TRANSMISSION—5R44E OR 5R55E—FLUID LEAK AT SERVO COVER—VEHICLES PRODUCED 6/1/2001 THROUGH 3/31/2002 EQUIPPED WITH 2.3L, 3.0L OR 4.0L ENGINES	Article No. 02-8-3

FORD: 2001-2002 EXPLORER SPORT TRAC, EXPLORER SPORT, RANGER

Figure 1 - Article 02-8-3

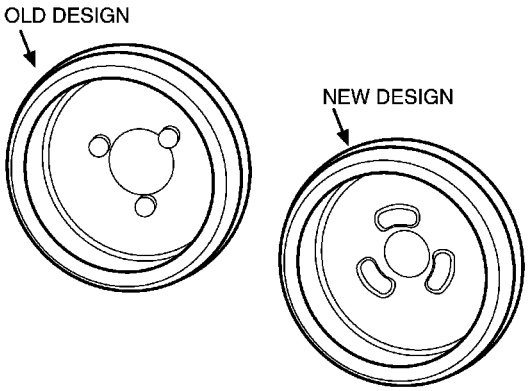
Some vehicles equipped with a 2.3L, 3.0L or 4.0L engine and 5R44E or 5R55E automatic transmission, produced 6/1/2001 through 3/31/02, operating in cold climates, may exhibit a fluid leak at the transmission Servo Cover(s). This may be caused by the Servo Cover.

Verify the condition. If the condition exists, the Servo Cover(s) may need to be replaced with new cover(s) (Figure 1). Check the transmission fluid level and fluid condition. If fluid is just low and the fluid condition is not burnt, refer to the following Service Procedure to replace the Servo Cover(s). If the transmission shows evidence of damage due to no fluid, no engagements or severely burnt fluid, the transmission may need additional repair or replacement. Follow normal repair or replacement procedures when servicing anything other than the Servo Cover(s).

9. Lubricate Servo Cover Seal and install a new Servo Cover Assembly onto the piston and into the piston bore Refer to the Servo Cover Application Chart for Servo Cover applications.
10. Install special service tool 307-340 (T95L-77028-A).
11. Tighten special tool to compress the Servo Cover and spring.
12. Install retaining ring.
13. Slowly remove the tension on the J-hook nut and remove the Servo Cover compressor. Clean residual fluid from Servo Cover area.
